CITY OF GRIFFIN
GRIFFIN GOLF COURSE BRIDGE REPLACEMENTS
BID # 24-007

FROM: PARAGON CONSULTING GROUP, INC.
350 AIRPORT ROAD
GRIFFIN, GA 30224

RE: Addendum No. 2, dated March 5, 2024

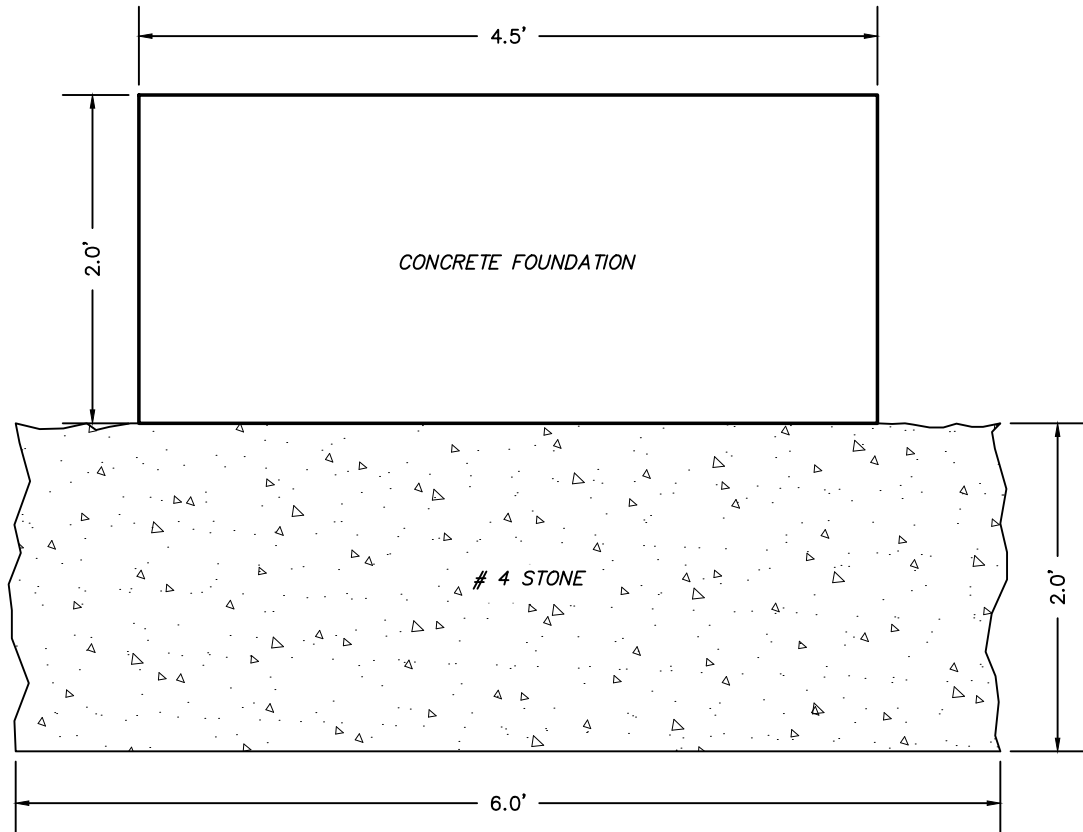
- Add. 1.10 Modification: A supplemental drawing titled 'Foundation Stone Detail' (SD-1) is attached to this Addendum and becomes a part of the Contract Documents.

NOTE: CONCRETE FOUNDATION LENGTH = 18'
